Form 3160-5
(June 2019)UNITED STATES
DEPARTMENT OF THE INTERIOR
BUREAU OF LAND MANAGEMENTFORM APPROVED
OMB No. 1004-0137
Expires: October 31, 2021**SUNDRY NOTICES AND REPORTS ON WELLS**
Do not use this form for proposals to drill or to re-enter an
abandoned well. Use Form 3160-3 (APD) for such proposals.

8. Well Name and No. PEGASUS 3 FED COM/207H

EOG respectfully requests an amendment to our approved APD for this well to reflect the following changes:

Modelo 3 Fed Com 531H (FKA Pegasus 3 Fed Com 207H)

WELL LOCATION AND ACREAGE DEDICATION PLAT

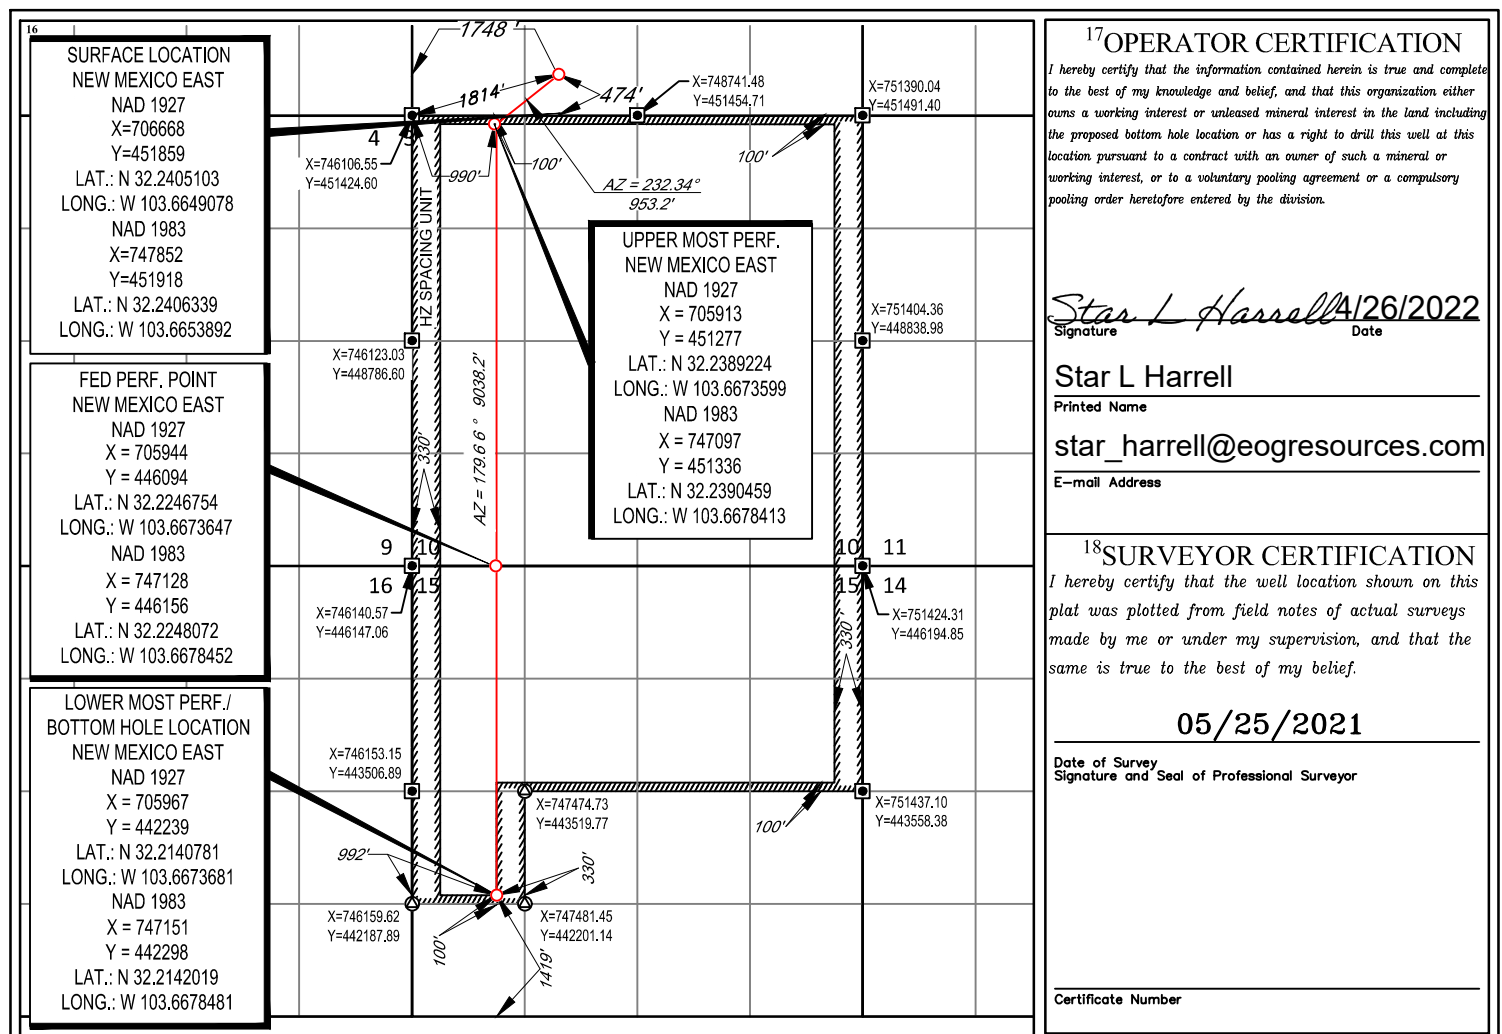
Change BHL from T-23-S, R-32-E, Sec 34, 100' FNL, 990' FWL, Lea Co., NM,
to T-24-S, R-32-E, Sec 15, 1419' FSL, 992' FWL, Lea Co., N.M.

UL or lot no.	Section	Township	Range	Lot Idn	Feet from the	North/South line	Feet from the	East/West line	County
L	15	24-S	32-E	-	1419'	SOUTH	992'	WEST	LEA

Figure 1: Cameron TA Plug and Offline Adapter Schematic

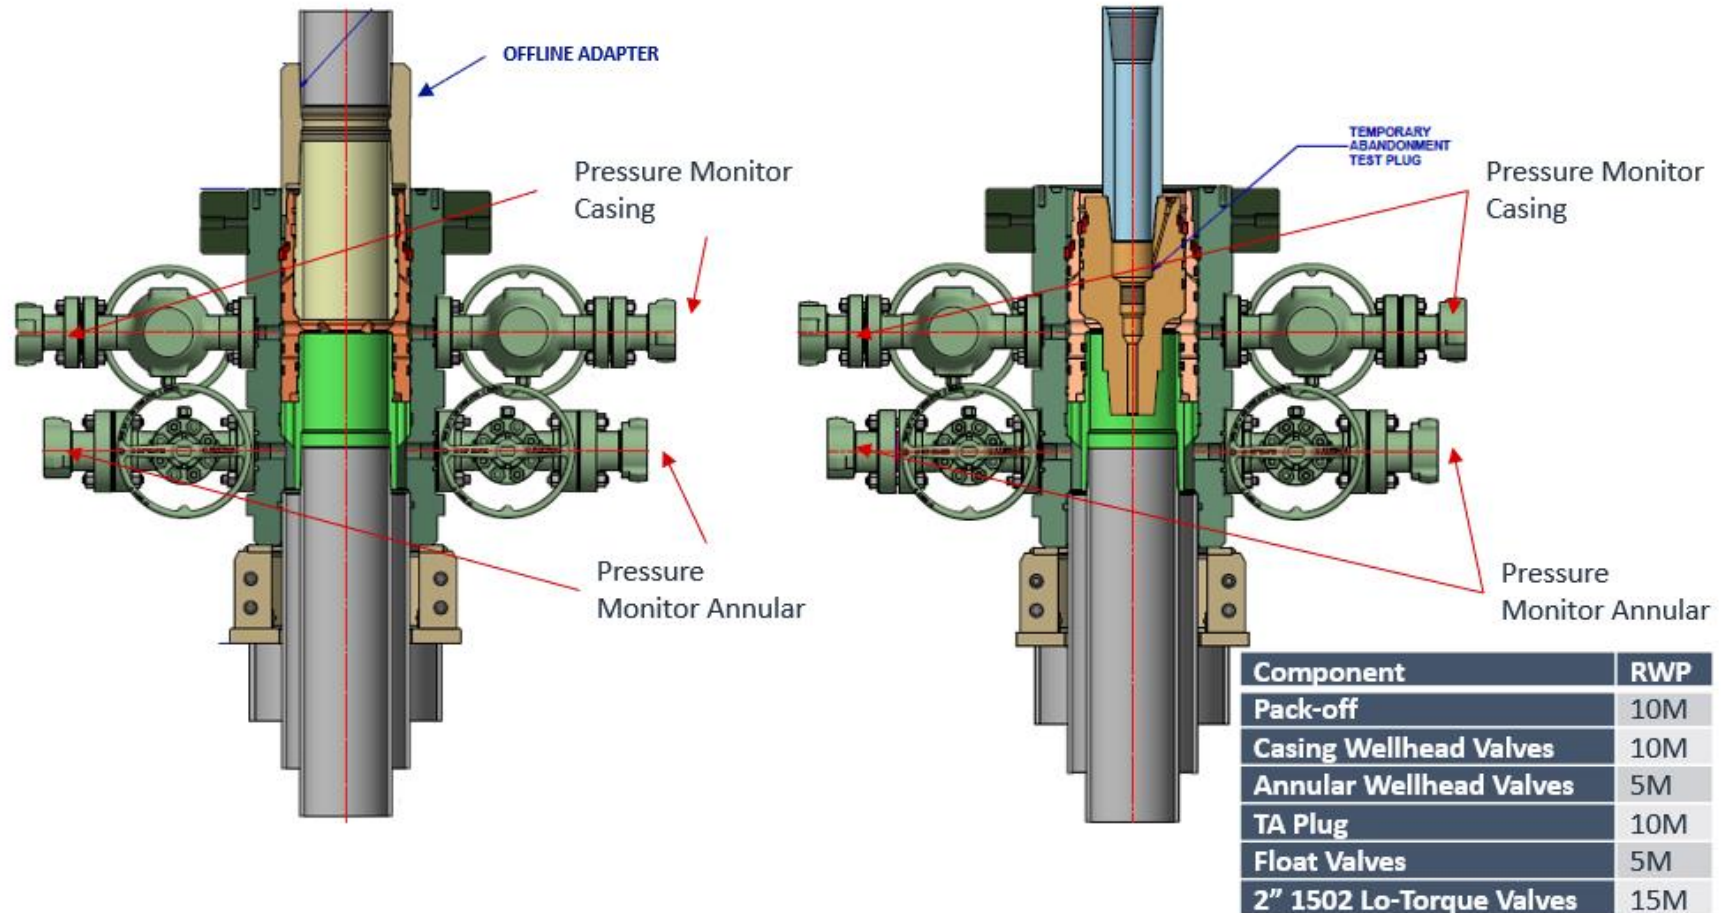
- c. Return line schematics can be seen in Figure 3.
10. Remove TA Plug from the casing.
11. Install offline cement tool.
 - a. Current offline cement tool schematics can be seen in Figure 1 (Cameron) and Figure 2 (Cactus).

Figure 3: Back Yard Rig Up

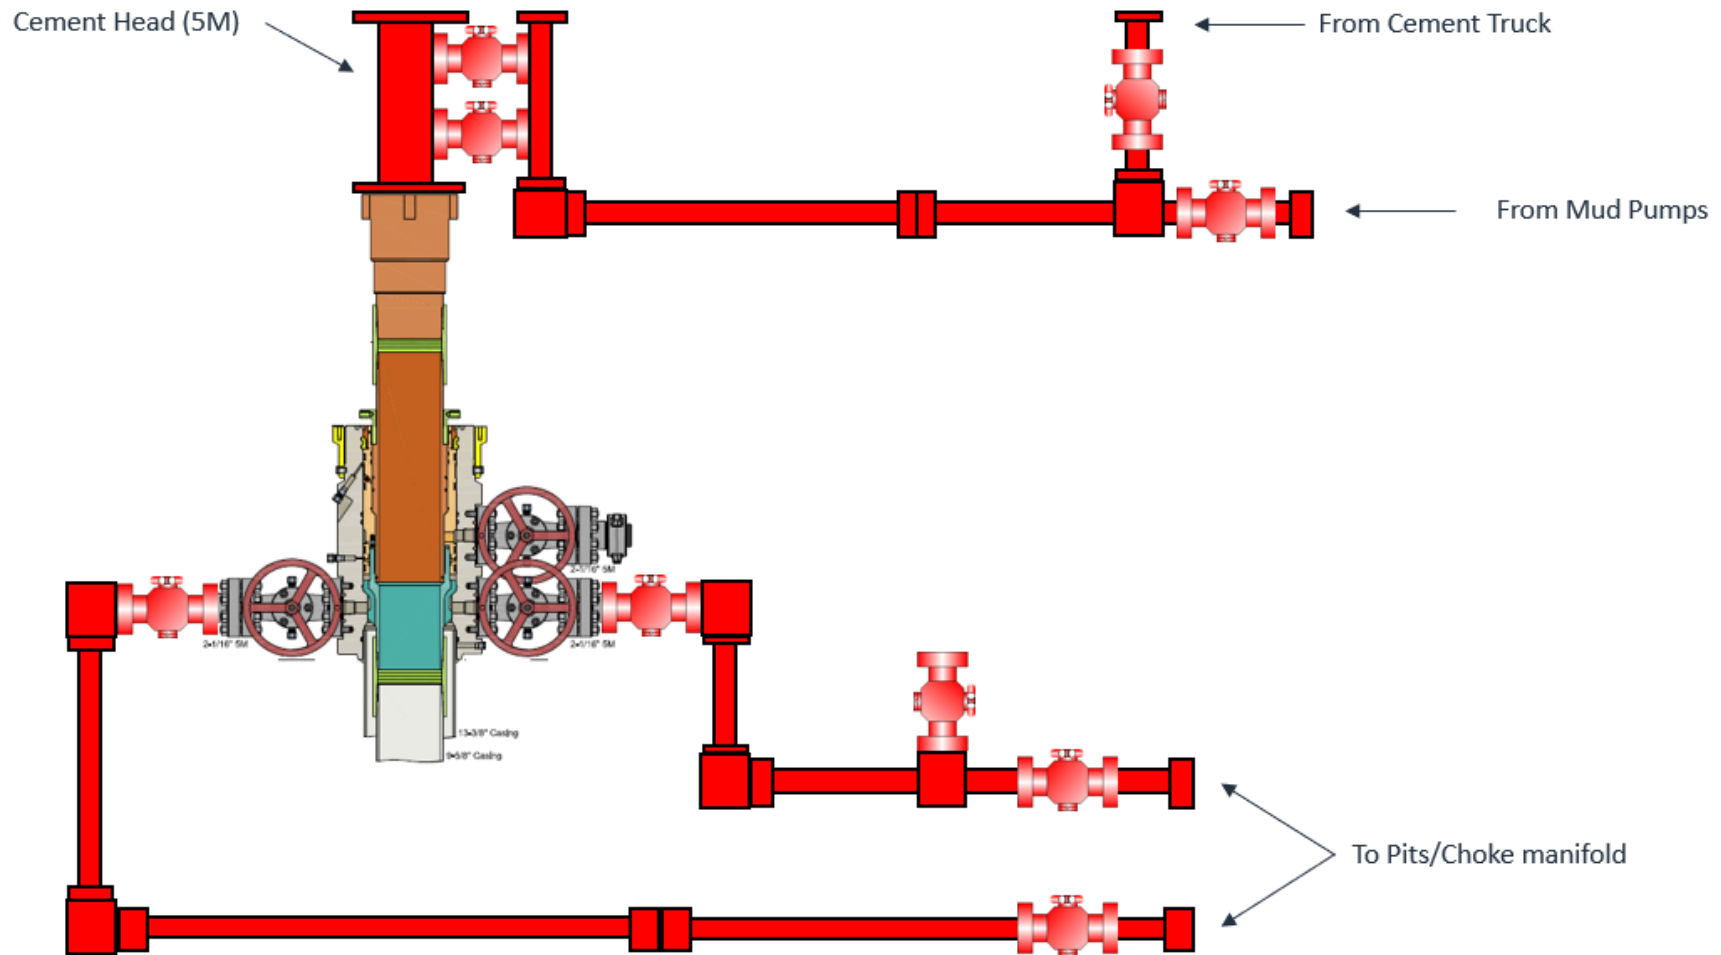
- a. Test all connections and lines from wellhead to choke manifold to 5,000 psi high for 10 min.
 - b. If either test fails, perform corrections and retest before proceeding.

Figure 4: Rig Placement Diagram

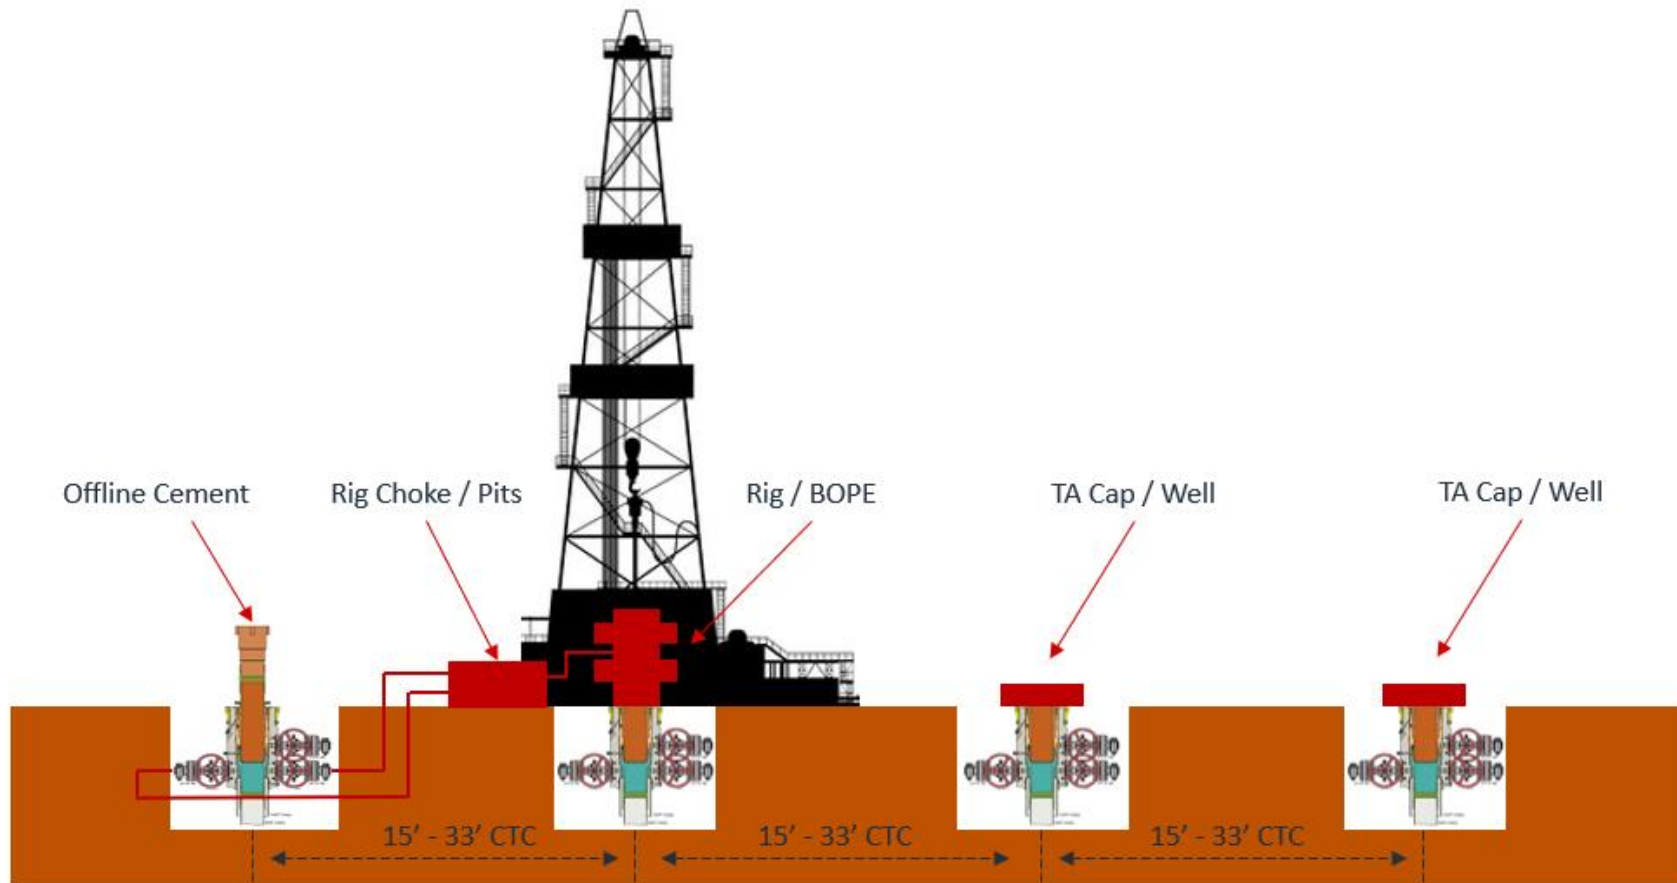
- e. Diagram for rig positioning relative to offline cementing can be seen in Figure 4.
9. Rig up return lines to take returns from wellhead to pits and rig choke.
